**SUBJECT:** RESOLUTION NO. 33, SERIES 2025 – A RESOLUTION  
APPROVING A PLANNED UNIT DEVELOPMENT AMENDMENT TO  
ALLOW CONSTRUCTION OF A 16,294 SQUARE FOOT  
INDUSTRIAL / FLEX SPACE BUILDING AT 517 S. ARTHUR  
AVENUE

**DATE:** MAY 20, 2025

**PREPARED BY:** MATT POST, SENIOR PLANNER

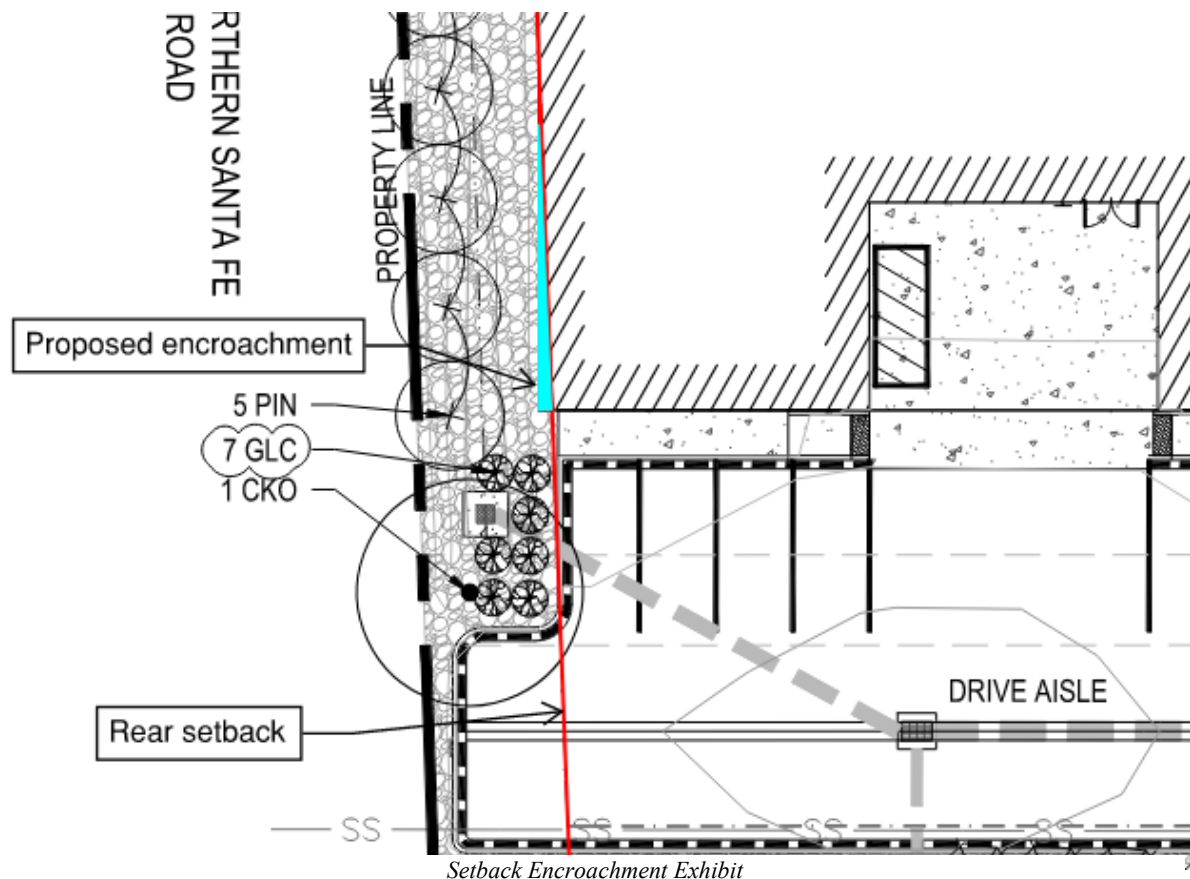
- Section 2.1.1.C of the IDDSG requires a two-way drive aisle width of 28 feet. The applicant is requesting a waiver to allow a reduced drive aisle width of 24 feet. Staff supports this request, as the Louisville Fire Protection District has confirmed that a 24-foot width is sufficient to accommodate emergency access on the site where aerials apparatus access requirements are not applicable. Additionally, a 24-foot drive aisle width aligns with modern development practices for efficient site design and functionality. **Staff support this waiver request.**
- Section 5.2.A.1 of the IDDSG requires a 10-foot wide landscape buffer between properties within the same district. Within the buffer area, one tree for every 30 linear feet shall be planted for half the depth of the lot, in addition to shrubs and/or ground cover.

Due to specific site constraints, the applicant is requesting a waiver to allow a reduced buffer width in two locations. At the southwest corner of the site, the buffer narrows to 2' 2 ½" to accommodate an extended drive aisle. This configuration is necessary to provide adequate access and maneuverability for fire apparatus and to meet applicable emergency service requirements. Along the southern edge of the property, the landscape buffer is reduced to 7' 6" due to the presence of multiple easements, which significantly limit the available planting area and restrict the placement of permanent landscaping features.

In response to these constraints, the applicant has proposed an alternative solution that includes a row of dense, mid-height shrub plantings in the affected areas. These plantings will effectively provide visual screening and enhance the site's aesthetic appeal. The proposed shrub species will mature to heights ranging from 5

to 10 feet, ensuring adequate buffering while maintaining flexibility in the site's layout.

Staff finds that the overall intent of the buffer standards, providing separation and visual relief between uses, has been maintained. **Staff support this waiver request**

## Parking Reduction Request:

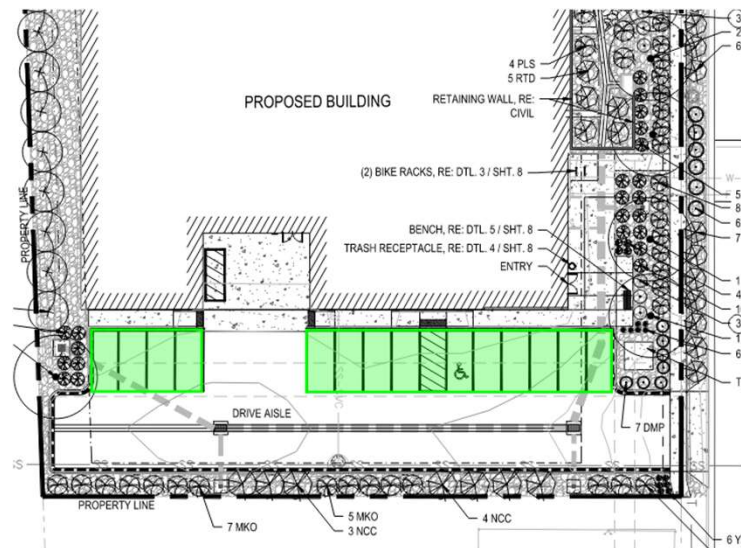
- 23 parking spaces required
- 14 spaces proposed
- EV charging provided in accordance with proposed spaces.

## Waiver request:

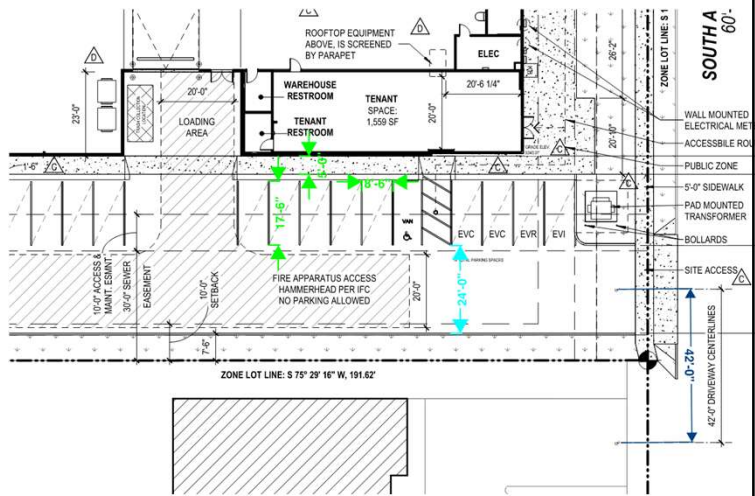
- Parking space size
  - 9' x 19' required – 8' 6" x 17' 6" proposed
- Two-way drive aisle width
  - 28 feet required – 24 feet proposed
- Driveway separation between properties
  - 75 feet required – 42 feet proposed

## Waiver request:

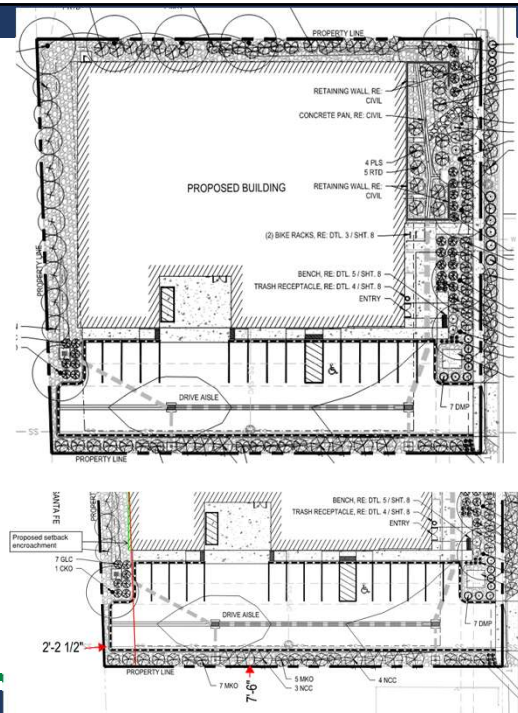
- Landscape buffer
  - 10 feet required – 2' 2 1/2" and 7' 6" requested.
- Rear setback
  - 15 feet required – 13' 6" proposed
- Landscape coverage
  - 25% required – 24% proposed
- Trees
  - 24 required – 22 proposed
